**Bodie Hills RV Park  
Revised Specific Plan &  
Final Environmental Impact Report (FEIR)**

**Volume II:  
Technical Appendices**

**Bodie Hills RV Park  
Revised Specific Plan and Final EIR**

**SCH# 97012031**

**MAP OF SITE NUMBERS  
REFERENCED IN NRCS REPORT  
DATED 5/19/99**

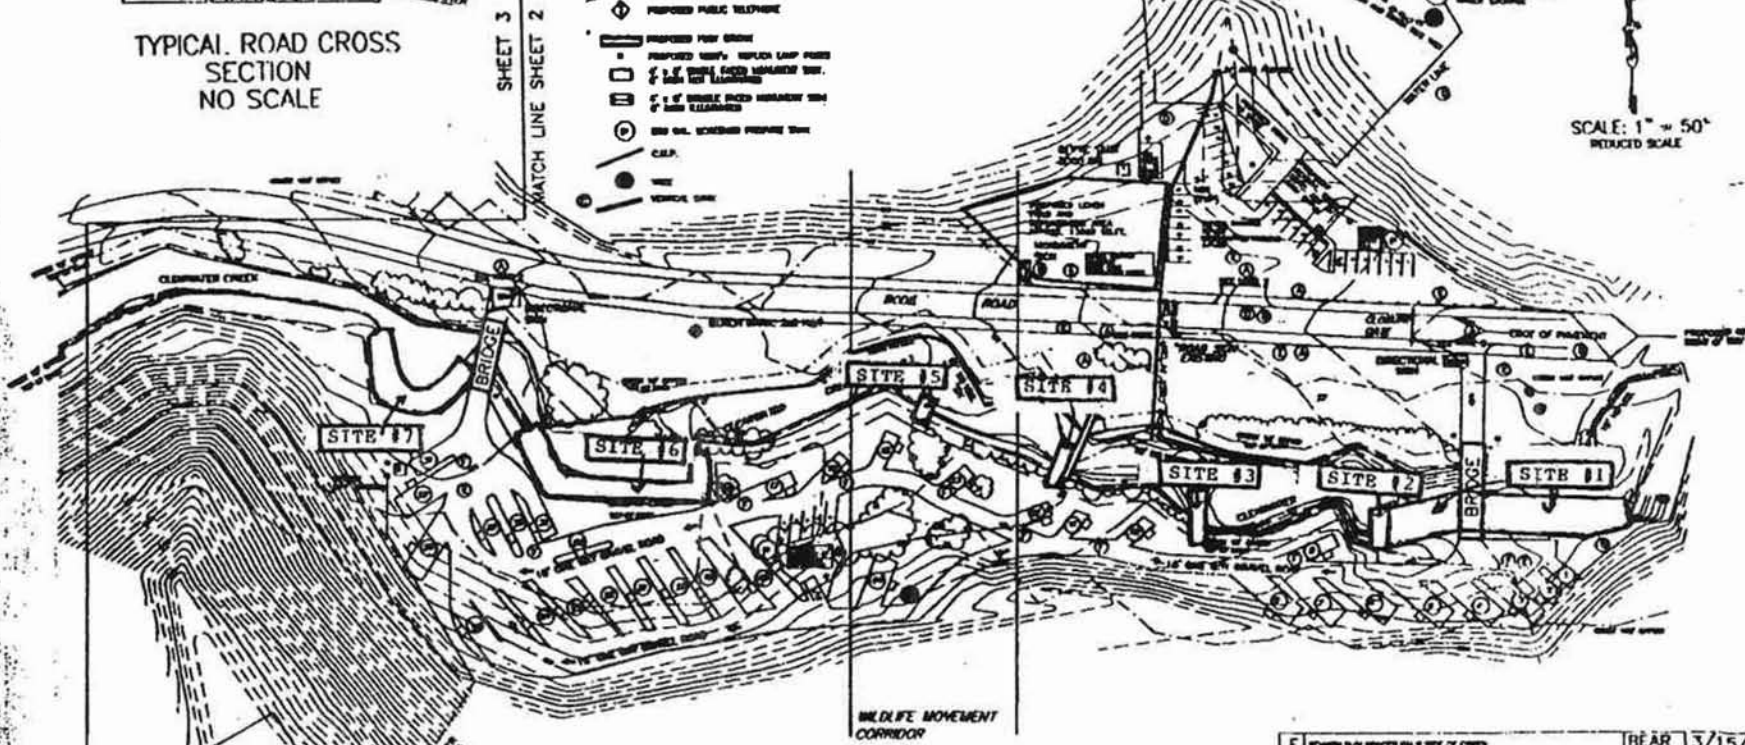
**SITE #2:** Clearwater Creek makes a turn to the north, and there are vertical banks on the south side. See Photo #1. Only 30 feet of the streambank is actively eroding at the downstream end of the curve. The upstream part of this curve has stabilized with a cover of willows. Directly behind the eroding area, a tributary (ephemeral) channel feeds into Clearwater Creek from the south side. The developer plans to install a culvert in this tributary and cover the culvert with soil. The toe of the actively eroding area on the streambank should be excavated and rock should be keyed-in to the bankfull elevation, sized appropriately according to engineering standards, and angular in shape. The bank above the rock toe protection can then be shaped to a 2:1 slope angle. Willows should be planted (entire willows can be transplanted if equipment is available) into a trench above the rock toe;

**SITE #3:** See Photo # 2. Clearwater Creek abruptly turns to the north at this spot. The lower 30 feet of streambank on the south side is actively eroding (toe erosion and bank undercutting mechanism) and requires stabilization in order to protect any developments planned for the area (Pad #10 and the gravel road connecting the RV pads would be located behind this site). Recommend same treatment as prescribed for Site #2, above. Rock toe protection to the bankfull elevation, bank reshaping to a 2:1 slope, and transplanting the existing large willow clumps at the top of the bank to a position above the new rock toe, to absorb and divert energy during high flows (or use brush layering). Seed remainder of bank with species adapted to the drier upper bank conditions.

**SITE #6:** This section of streambank, above the proposed western bridge, is an area which has evolved into a stable channel, except for the last 20 feet along the curve, which is still actively eroding. See Photo #3. The vertical banks seen on the left side of the photo (upstream end) are no longer actively eroding; the stream is now meandering through this segment, and willows provide protection to the toe of the slope. See Photo #4. The only work we would recommend on this upper portion is to reshape the upper vertical banks, to a 2:1 slope, if possible, and re-seed with the appropriate herbaceous seed mix. This will dramatically shorten the natural process of bank sloughing which will take many years for nature to complete, and provide a more aesthetic appearance to the area. Equipment should not disturb the existing vegetation along the stream. The bottom 20 feet of the curve should be laid back to a 2:1 slope and treated the same as for Sites 2-5, above with rock toe and vegetation planting.

**Site #7:** The final area of concern is located immediately downstream of the proposed western bridge site, and involves about 100 feet of streambank on the south side. Since there are no developments planned behind or below this segment of Clearwater Creek, any work done on this streambank would be for aesthetics, only. This segment of stream has also stabilized and reshaping the remaining vertical banks and replanting with a herbaceous seed mix would simply speed the natural process which is now occurring very slowly on site. See Photo #5. Again, the toe of the slope is already
